Appendix V

Tree Preservation and Landscaping Proposal
with Response-to-Comment

Comments from Planning Department dated 22.12.2025

REZONING APPLICATION FROM “AGR” AND “GB” TO “OU (COLUMBARIUM)”
ON VARIOUS LOTS IN D.D. 41 AND ADJOINING GOVERNMENT LAND,
TONG TO, SHA TAU KOK, N.T.

DRAWING No. LMP02

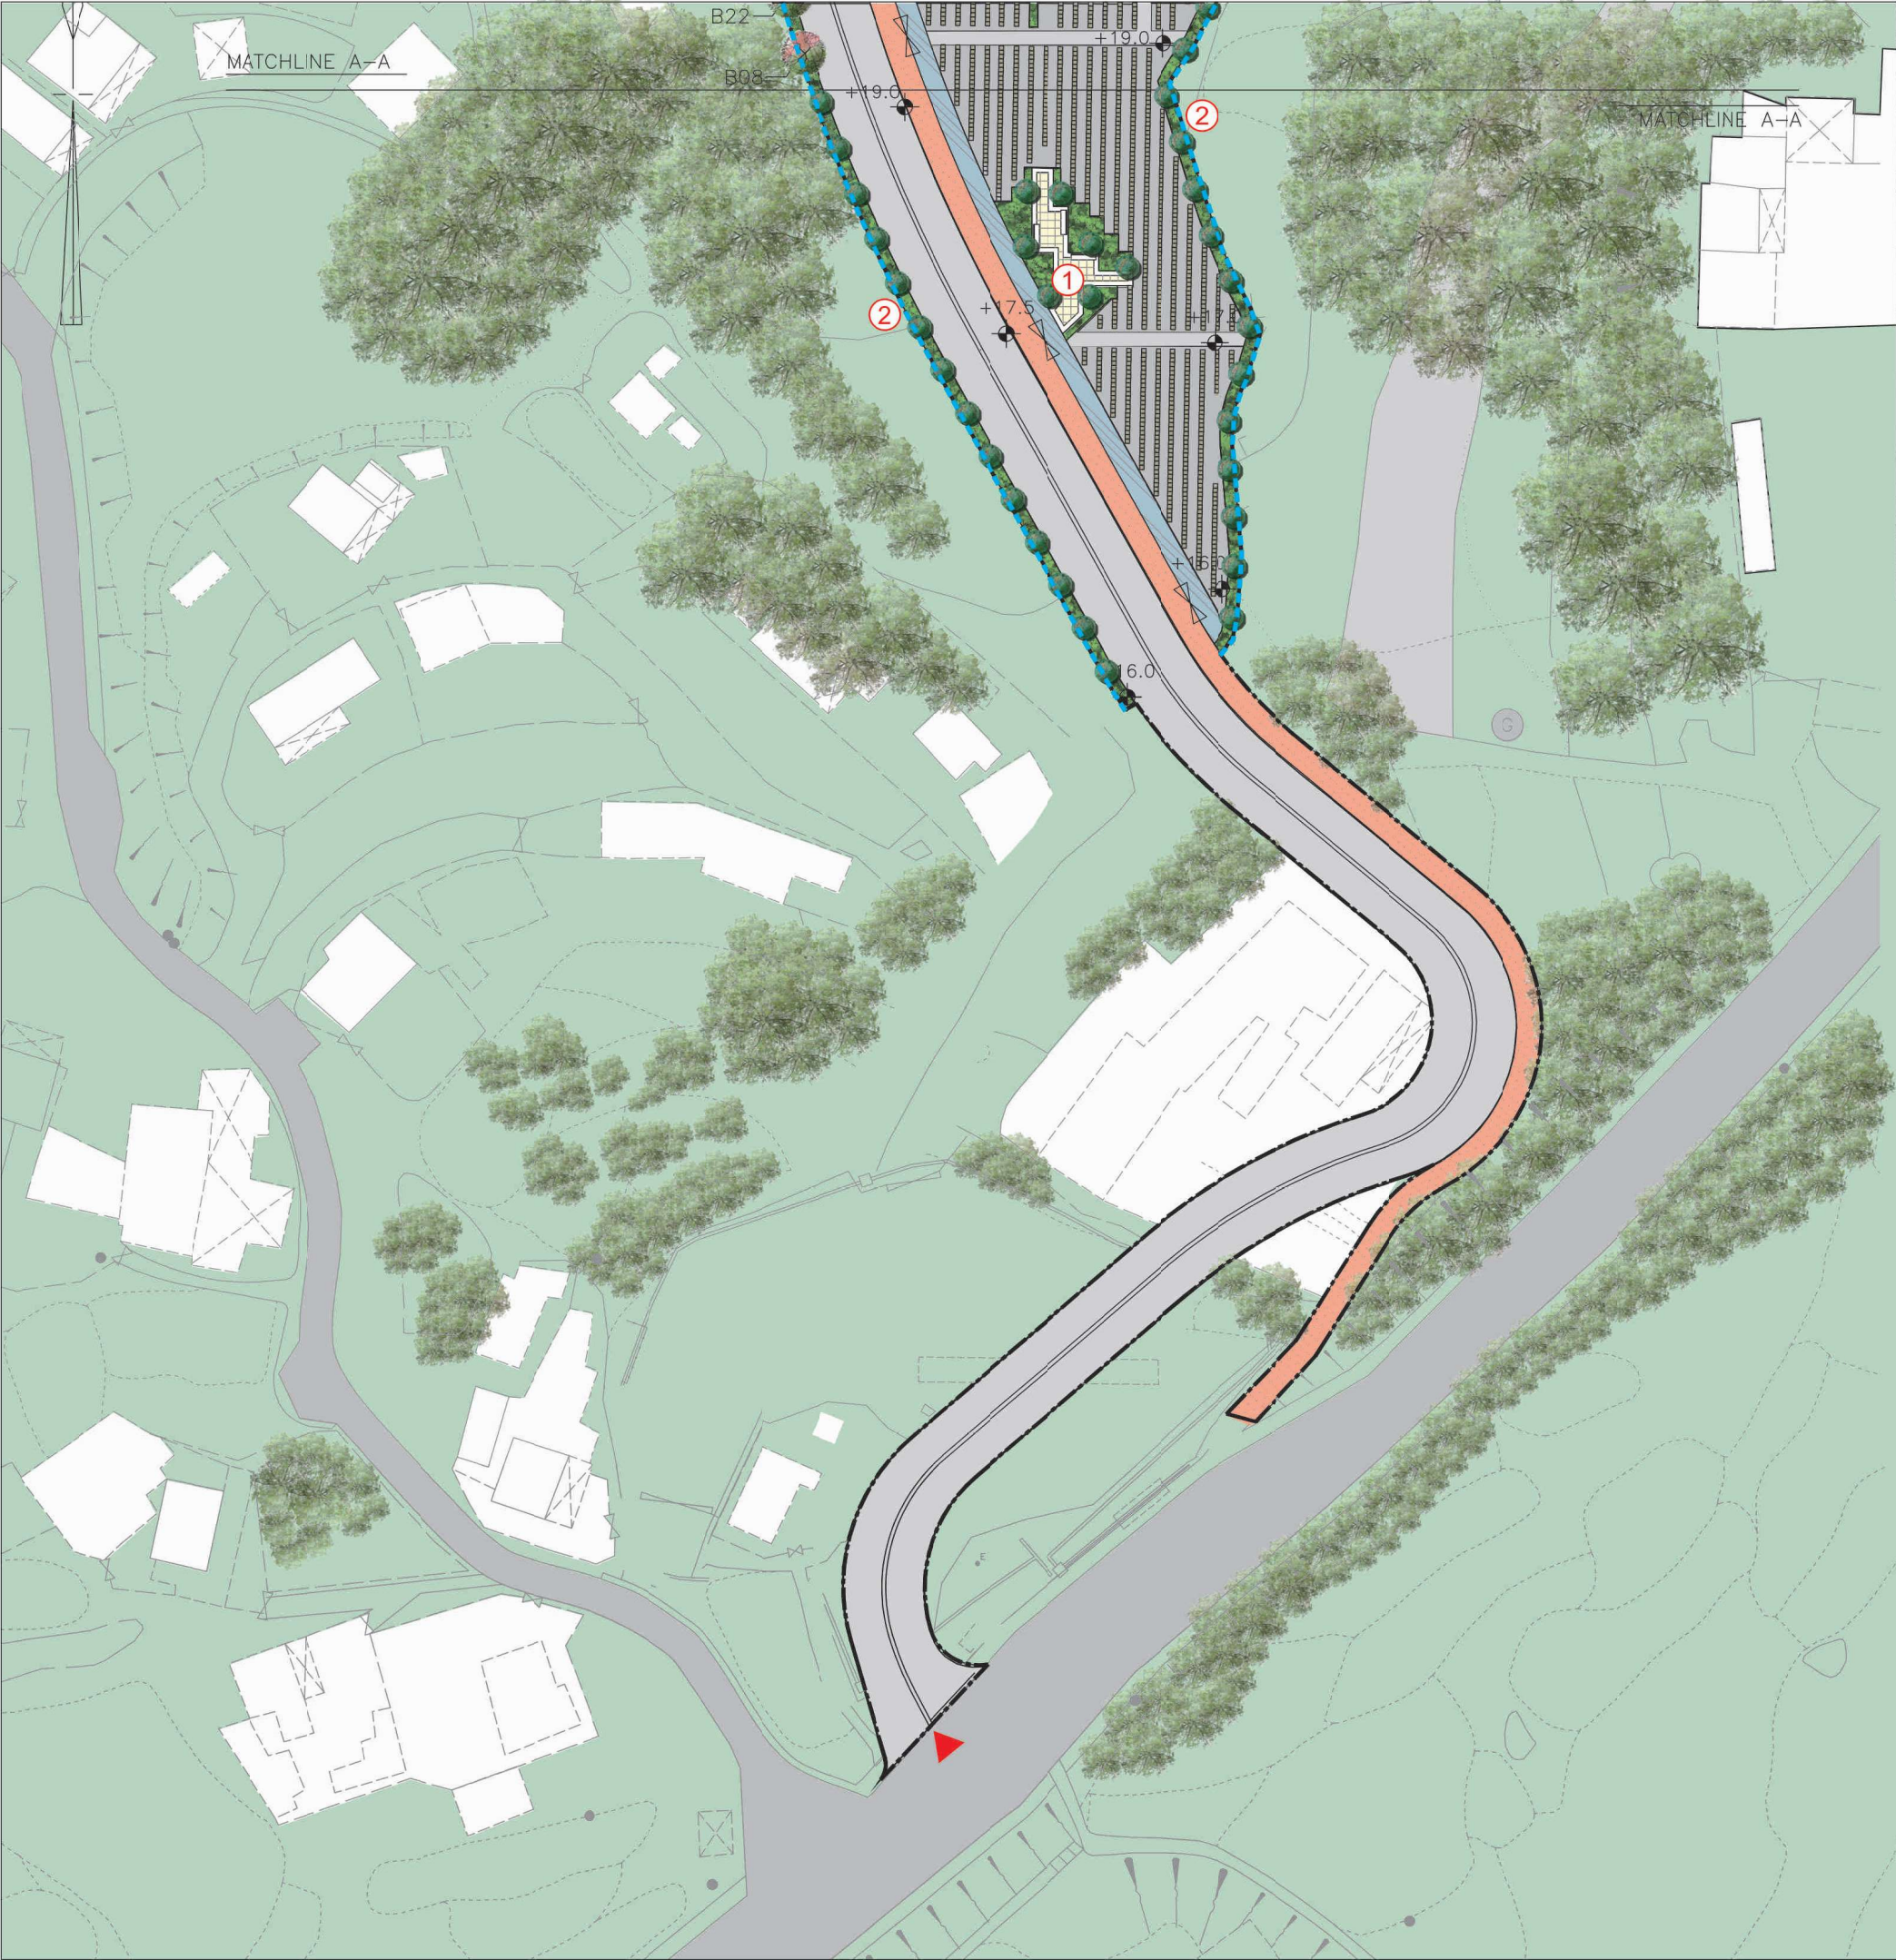
Comments		Responses
	Comments on the Tree Preservation and Landscaping Proposal		
7.	Appendix II Landscape Master Plan – It is observed the height (2.5m) and the location (eastern tip of the Site) of the fence wall does not tally with the Plan 4b of the PS. Comment (6) above is relevant.		Appendix II Landscape Master Plan (LMP02) is updated to tally with Plan 4b of the planning statement.
